Access Compliance Report

Public Rights-of-Way

Intersection ID: 6347	Main Street: DALPHON_JONES_DR	Cross Street: KATHERINE_KIKER_RD	Location: W
ADA ID: BF50ACD74A9A	Ramp Type: BlendTrans1	Initial Pass/Fail: Pass	Overall Compliance: No
Severity Score: 22.5			
Codes/Mitigation Info/Possible Solution		Field Measurements/Component Compliance

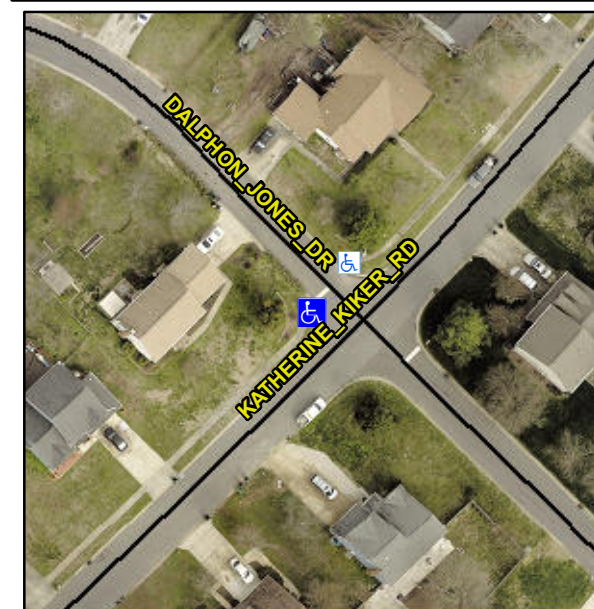
NO RT SW

Not Found, R304.2.1, R305, R302.7.2, R304.5.4

Remove & Replace Curb Ramp With Two New Directional Ramps or Equivalent. Remove & Replace Gutter.
